Interactive comment on “Methane cross-validation between three Fourier Transform Spectrometers: SCISAT ACE-FTS, GOSAT TANSO-FTS, and ground-based FTS measurements in the Canadian high Arctic” by G. Holl et al.

Received and published: 8 March 2016

2 Anonymous Referee #1

Fig. 1. Repetition of Figure 17 from the manuscript, but for the linear regression, excluding any data points that deviate from the median by more than 5 times the median absolute deviation.

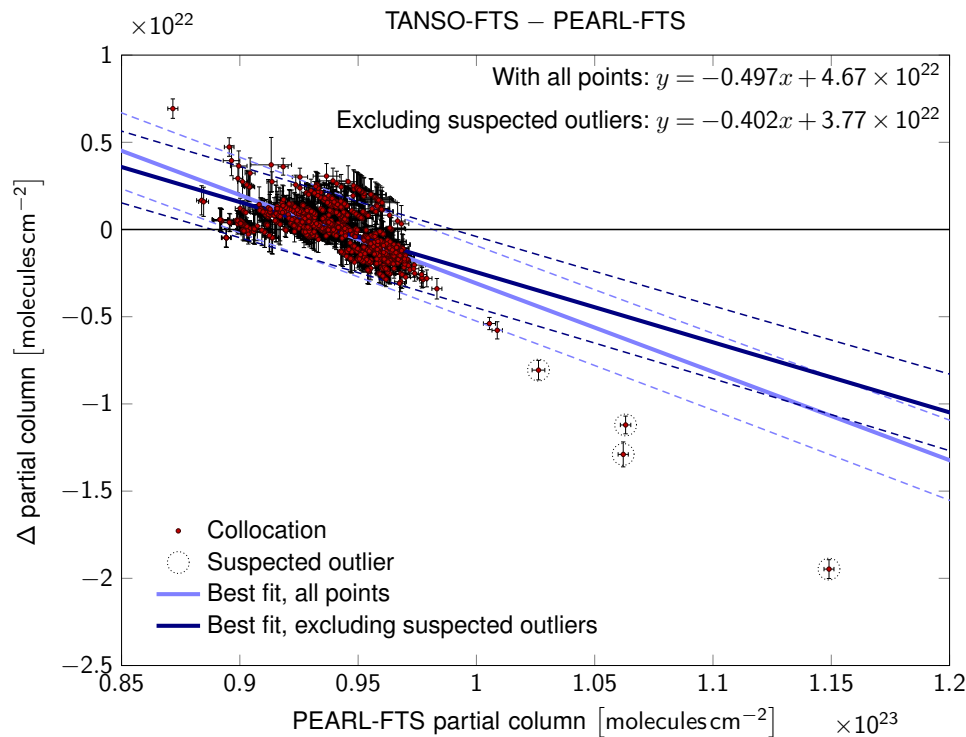
Figure 17 and discussion on page 1322, Lines 15-17: There are 4 points which look to be outliers on this plot. Outliers can greatly influence linear regression. Was linear regression without the outliers performed to make sure these points do not have a major effect on the result?

Although we are not convinced that the data points that deviate from the bulk are technically outliers (they might correspond to physically real situations), we have repeated the regression while removing any data points that deviate from the median by more than 5 times the median absolute deviation.

Figure 1 (shown at end of response) shows a repetition of Figure 17 from the manuscript, but with suspected outliers removed as described. The new prediction band lies slightly higher than the old one, but there is still considerable overlap between the two. Therefore, we conclude that those data points (which may or may not be outliers) do not significantly affect the regression. In the manuscript, we have replaced Figure 17 by the new figure and adapted the text accordingly.
